Application for Licence Amendment

Licence Number	L9034/2017/1
Licence Holder	Water Corporation
File Number	DER2017/000181
Premises	Advanced Water Recycling Plant Ocean Reef Road, CRAIGIE WA 6025 Legal description – Part of Lot 8278 on Plan 30778 As defined by the coordinates in Schedule 1 of the amended Licence.
Date of Report	9 April 2024
Decision	Revised licence granted

Figure 1: Location of AWRP in relation to surrounding area

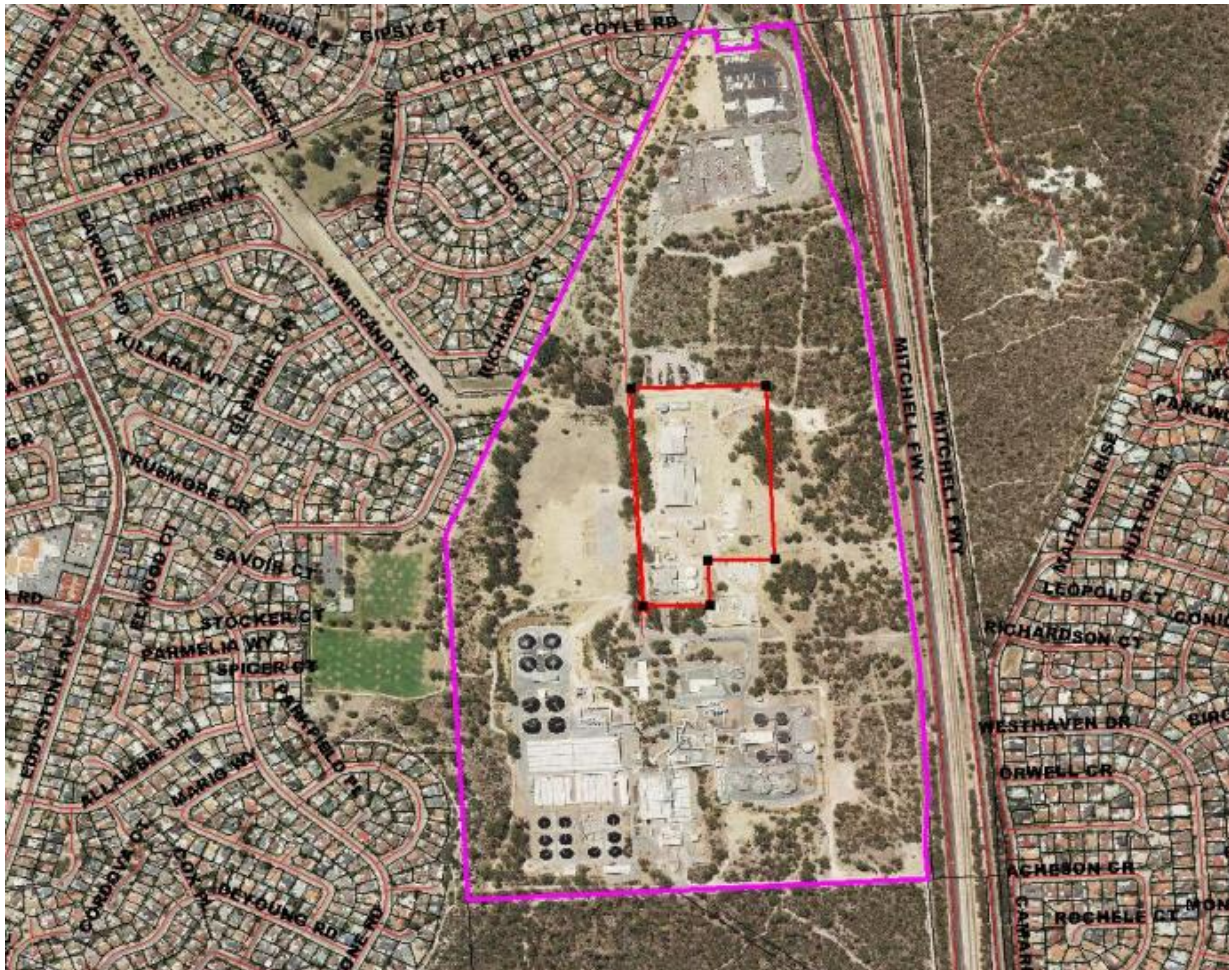
Condition	Summary of Licence Holder's comment	Department's response
		and will likely be part of the risk assessment should any changes be proposed to the Stage 2 scheme in the future.
N/A- Decision report 4.1.2	Lake Joondalup is situated east of AWRP, not west.	Corrected.
N/A- Decision report 5.3	<p>There is not a superficial monitoring bores at the northern recharge site.</p> <p>At this time Water Corporation do not intend to install a superficial monitoring bore. Water Corporation have recently completed an assessment for DWER (Water Allocation Planning Branch) assessing the risk of GWR impacting Lake Joondalup. This concluded that there is no evidence that injection to the confined aquifers influences the superficial aquifer or Lake Joondalup</p>	<p>Noted.</p> <p>The Delegated Officer notes that since there is not a superficial monitoring bores at the northern recharge site, there is no way to monitor the potential risks and impacts of hydraulic head changes in the superficial aquifer from the full-scale stage 2 recharge scheme.</p> <p>As such, DWER may implement the construction and monitoring of a superficial bore at the northern recharge site through a subsequent amendment to the licence at a later stage. DWER will assess the need for this bore after the stage 1 groundwater review report has been submitted and reviewed by DWER officers.</p>
